Project	IEEE 802.16 Broadband Wireless Access Working Group < http://ieee802.org/16 >	
Title	CQI Channel Allocation during Sleep Model	
Date Submitted	206-09-22	
Source(s)	Yonah Lasker Alvarion	Voice: [Telephone Number] Fax: [Fax Number] [mailto:yonah.lasker@alvarion.com]
Re:	[If this is a proposed revision, cite the original document.] [If this is a response to a Call for Contributions, cite the name and date of the Call for Contributions to which this document responds, as well as the relevant item number in the Call for Contributions. Contributions that are not responsive to this section of the template, and contributions which do not address the topic under which they are submitted, may be refused or consigned to the "General Contributions" area.]	
Abstract	Suggestion to change approach for CQI Channel Allocation during Sleep Model	
Purpose	For the review in 802.16 Maint TG	
Notice	This document has been prepared to assist IEEE 802.16. It is offered as a basis for discussion and is not binding on the contributing individual(s) or organization(s). The material in this document is subject to change in form and content after further study. The contributor(s) reserve(s) the right t

Figure X - CQI transmissions during sleep mode

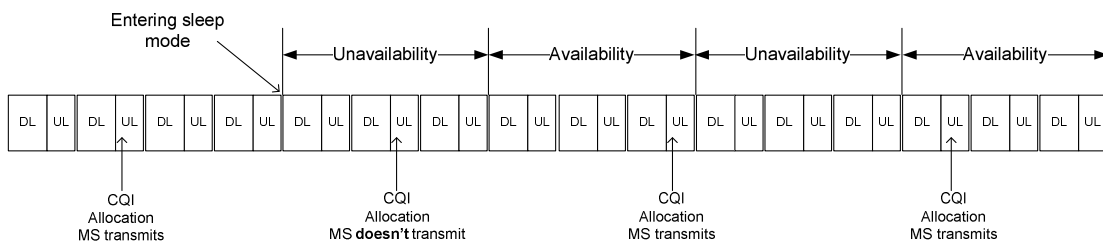
An example is given in figure X:

Add the following figure in 8.4.5.4.12 before table 300:

An MS in sleep mode (during the unavailability interval) shall not transmit on the assigned CQICH. If while in sleep (with traffic triggered waking flag = 1), the MS transmits a bandwidth request with respect to a connection belonging to the Power Saving Class, the MS shall **continue to transmit on the CQI allocated to it. not transmit on the CQICH until receiving a response to the bandwidth request.**

An MS in sleep mode during the availability interval shall continue to transmit on the CQICH slots allocated to the MS.
